Public Art Research and Design RFP
Questions and Answers

3.6.2020

Parcel 19 - Atlantic Ave & Pearl St

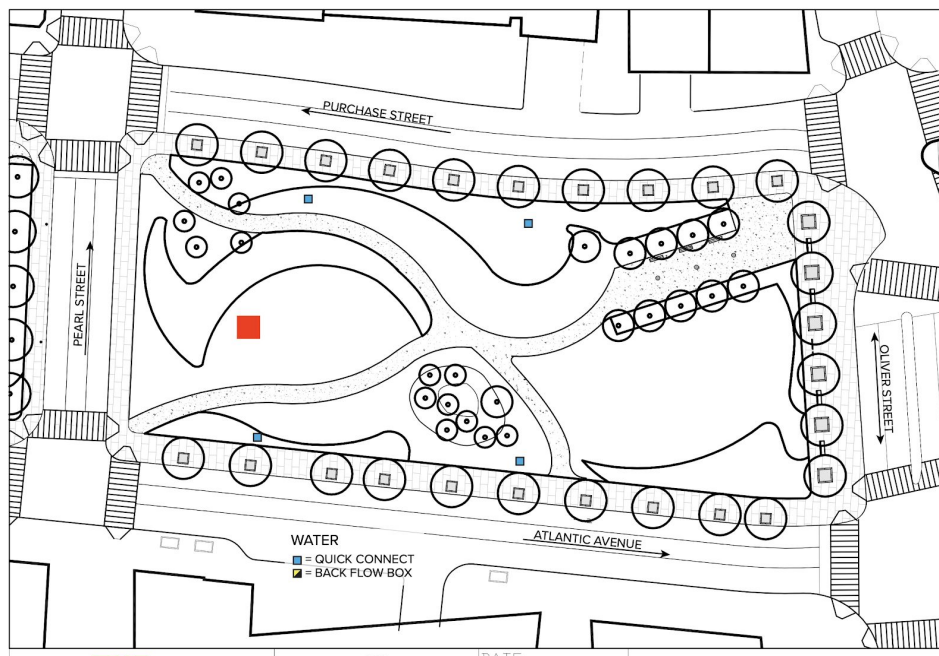
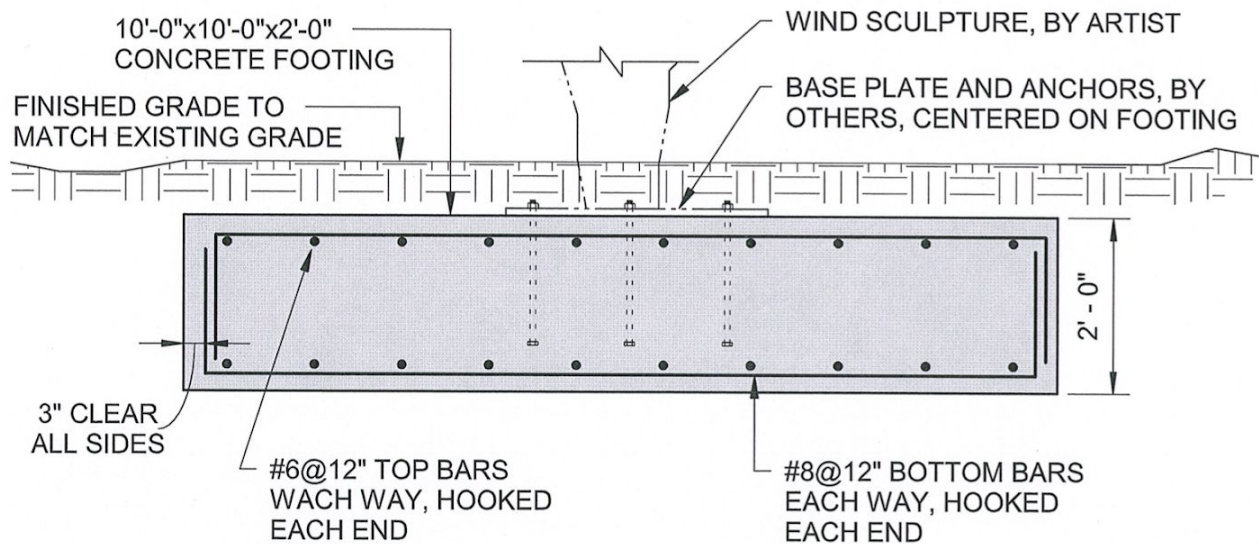
Three lawn sites on The Greenway have existing footings in the lawns, which may be used for the artwork. See Attachment B for locations and details of existing and incoming footings.

In 2020, a new footing will be created on Parcel 19. The engineering drawing below illustrates this incoming footing. If desired, The Conservancy may leave this footing for a sculpture, with the expectation that it is removed at the end of the exhibit.
